PLANNING DEPARTMENT - Development Review Services

August 27, 2015

RE: Marie Hughes Elementary School – 2701 Mojave Street, NW Grading and Drainage Plan for Building Permit Engineer's Stamp Date 7-31-2015 (D11D007)

C101

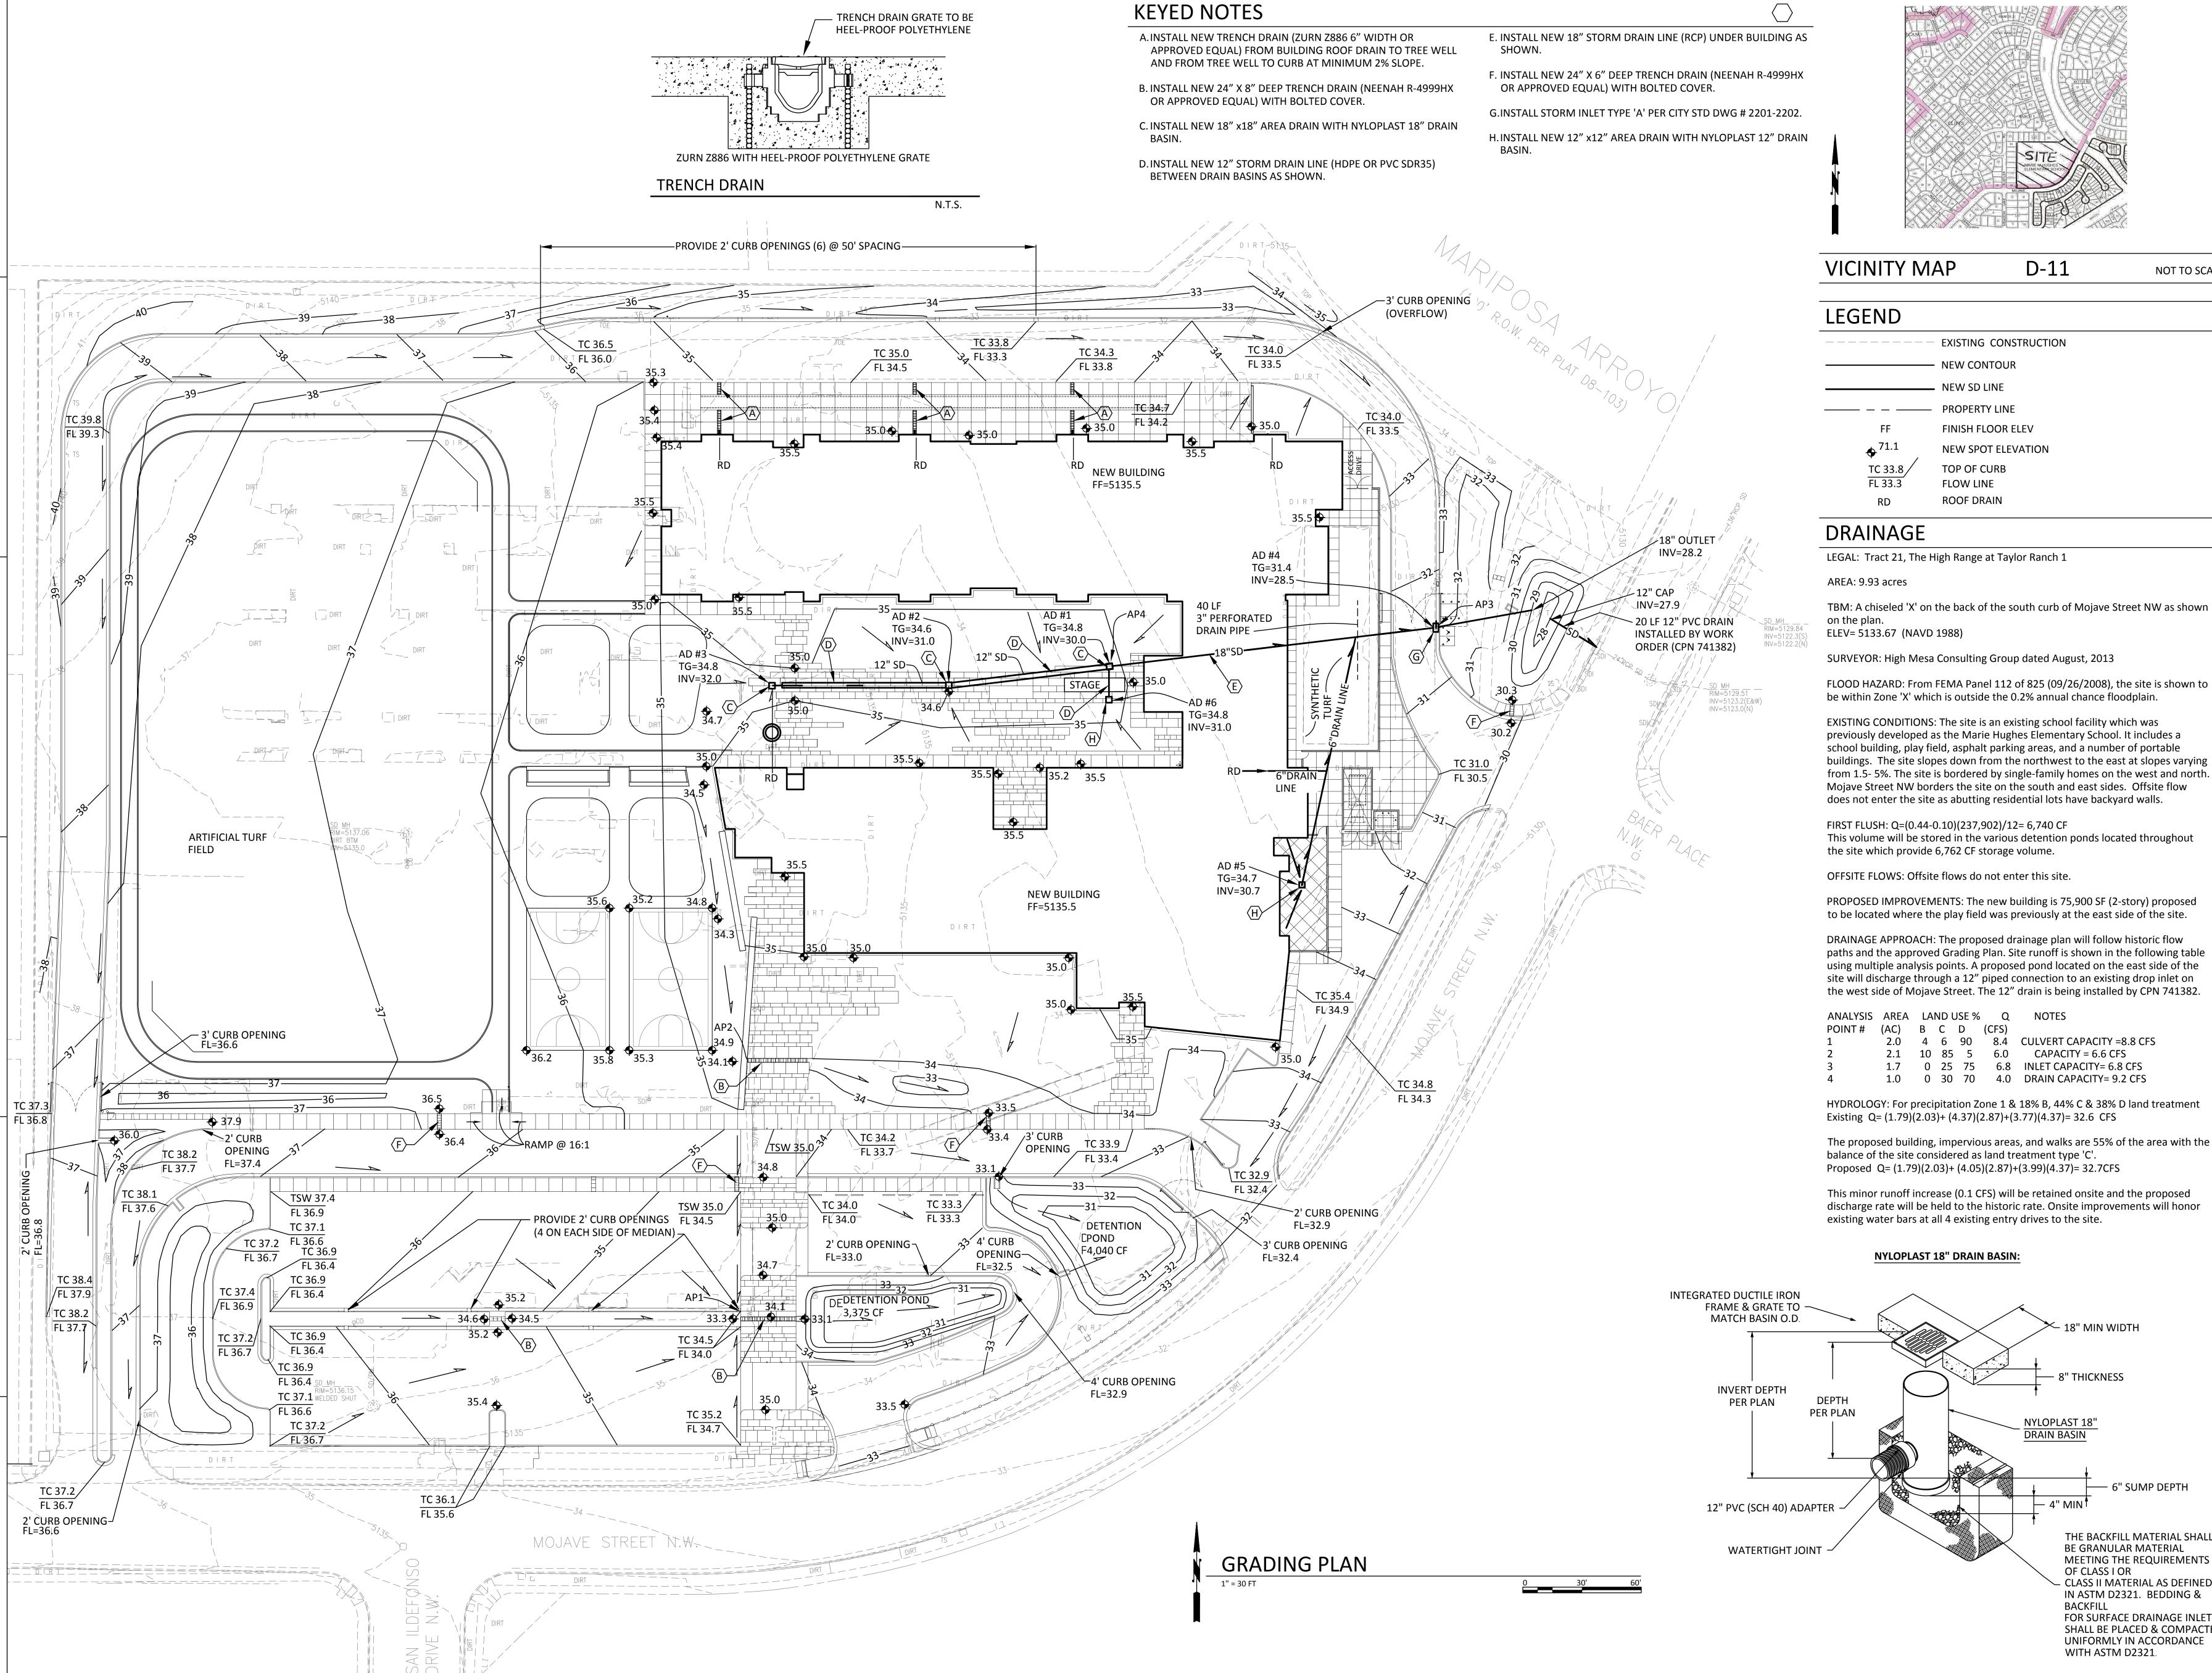
- 1. In the street capacity calculations:
 - a. Provide a basin map showing the upstream drainage area contributing to the street flows.
 - b. In the Manning's equation, show how input values are determined.

- c. Show that the inlets can collect flows from the street and this development without flooding.
 - d. Are inlets in a sump? Contour information is cut off.

- 2. The older plan by JMA in 1995 states that the outfall for this site was the Mariposa Diversion Channel, and there is already a penetration into the channel. Discharging directly into the Channel is the preferable option and should be re-evaluated. I believe there is already a penetration into the channel.

- 3. Analysis Points:
 - a. Provide calculations for inlet and culvert capacities shown on table in "Notes"
 - b. The 4 Analysis Points add to 6.8cfs, but the total is 32.7 cfs. Provide an onsite basin map showing the contributing flows from each basin.

- c. Show amount of flow at all discharge points into streets, ponds, inlets, etc.
 - d. Basin Map should show how much flow is going in private storm drain system. Provide capacity calculations for the private Storm Drain.

- 4. How much flow is discharging into the most easterly pond (connected to inlet)? How much flow is discharging out of pond? Since it is functioning as detention pond, what is the Max WSEL? Provide calculations.
